FINAL DRAINAGE REPORT ADDENDUM

ELLSWORTH ROAD
UNIVERSITY DRIVE TO MCLELLAN ROAD (PHASE II)

Maricopa County Project No. 68902

REVIEW COMMENT SHEET

Figure 5.31
Headwater Depth for Oval Concrete Pipe Culverts
Long Axis Horizontal with Inlet Control
(USDOT, FHWA, HDS-5, 1985)

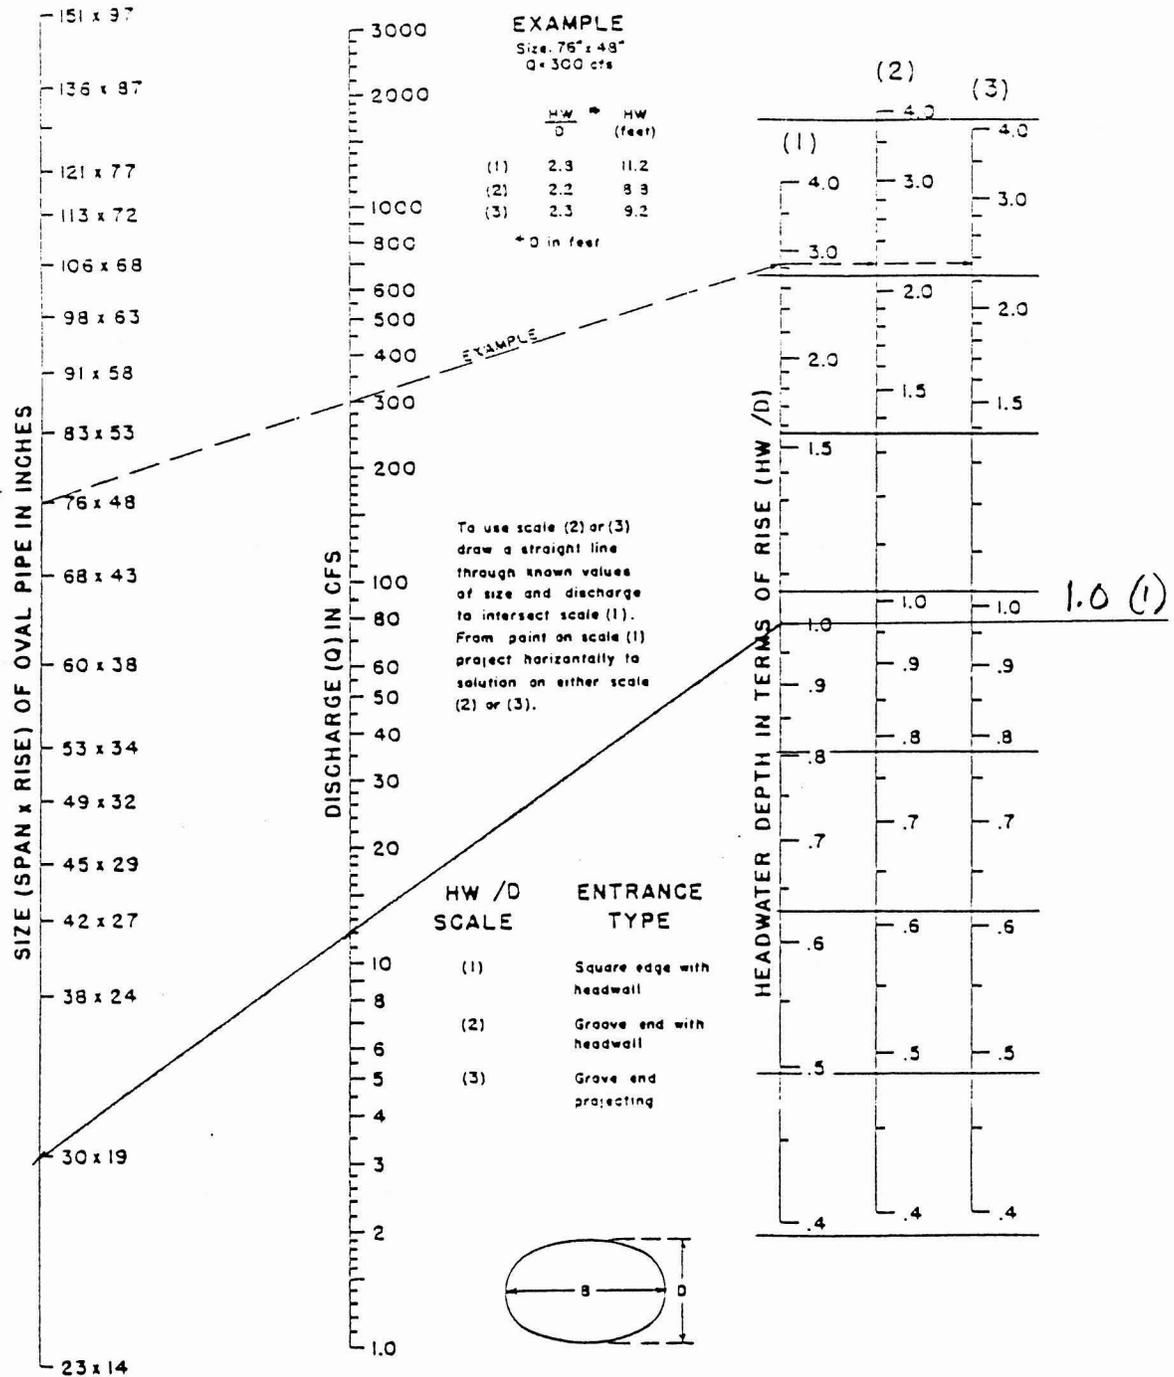
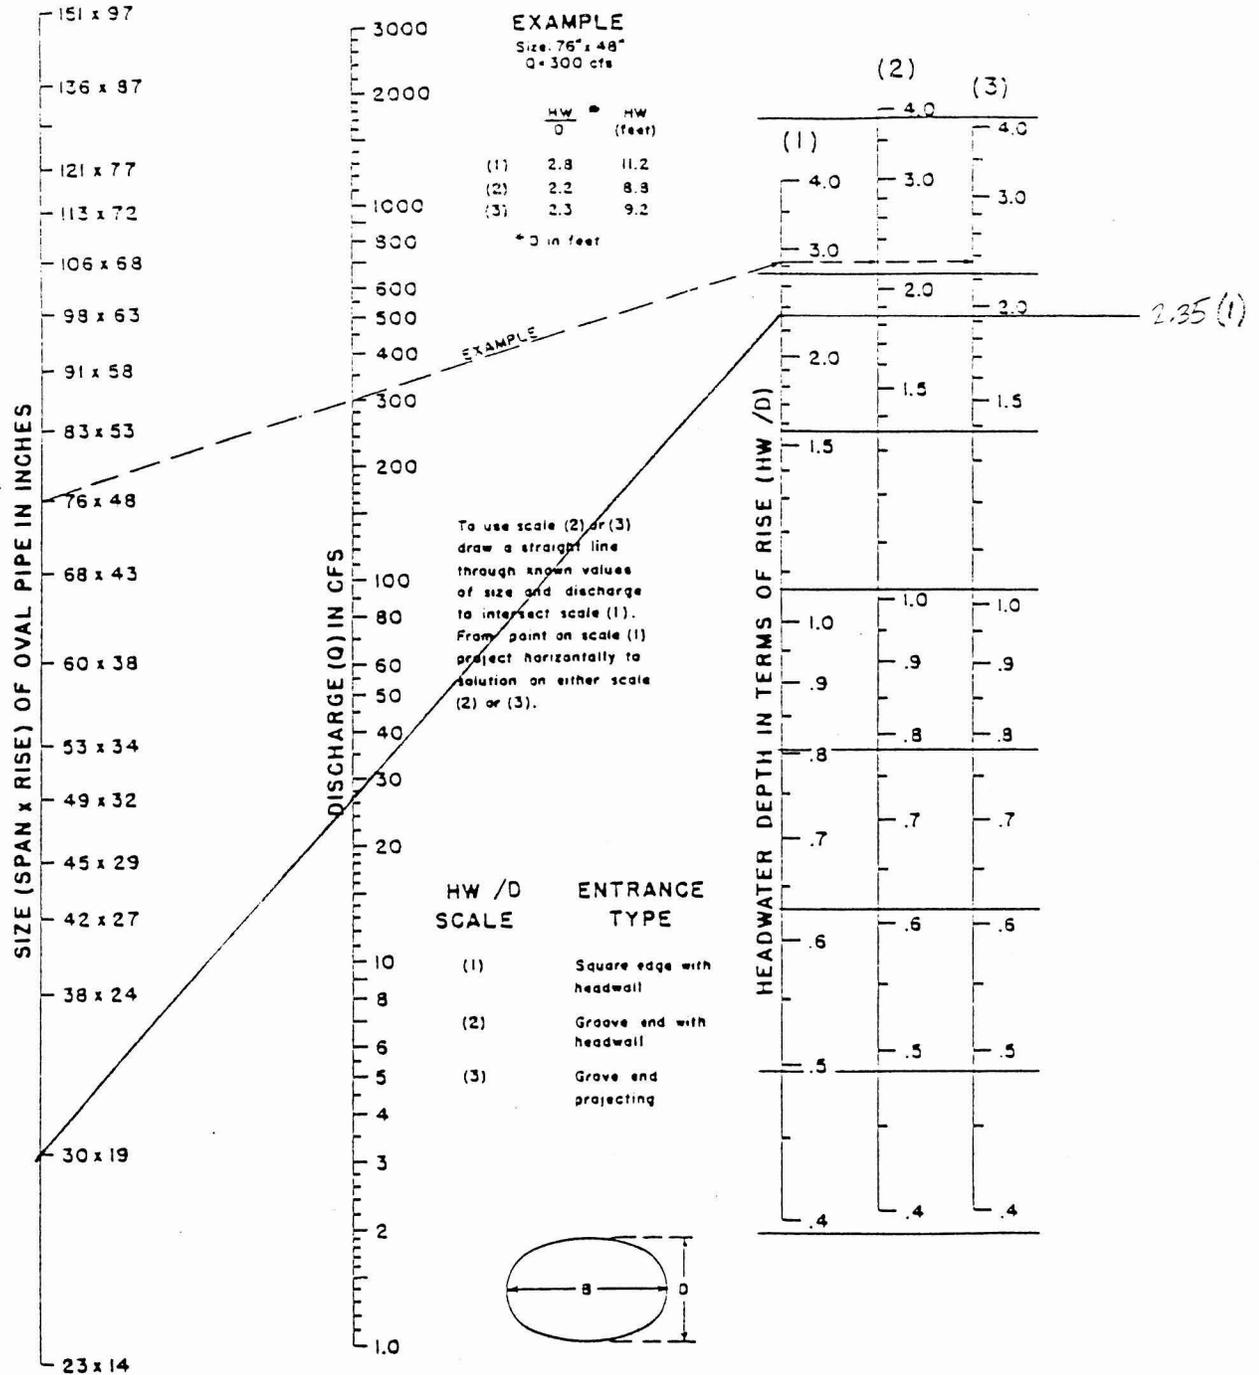
Headwater depths were completed using the Maricopa County Drainage Design Manual, Volume II for the elliptical culverts located at Sta. 7+733. The 50-year headwater elevation is 513.947 and the 100-year headwater elevation is 514.594. Flow depth over the road during the 100-year event is 0.119m. See attached Figure 5.31 for headwater depths.

50 yr Q = 0.68 m³/sec = 24.02 cfs

Flow for graph = 12.01 cfs/barrel

Headwater Depth = $1 * \frac{19}{12} = 1.58' = 0.483 \text{ m}$

100 yr $Q = 1.50 \text{ m}^3/\text{sec} = 53 \text{ cfs}$

Flow for graph = $26.5 \text{ cfs}/\text{barrel}$

Headwater Depth = $2.35 \times \frac{19}{12} = 3.72' = 1.13 \text{ m}$
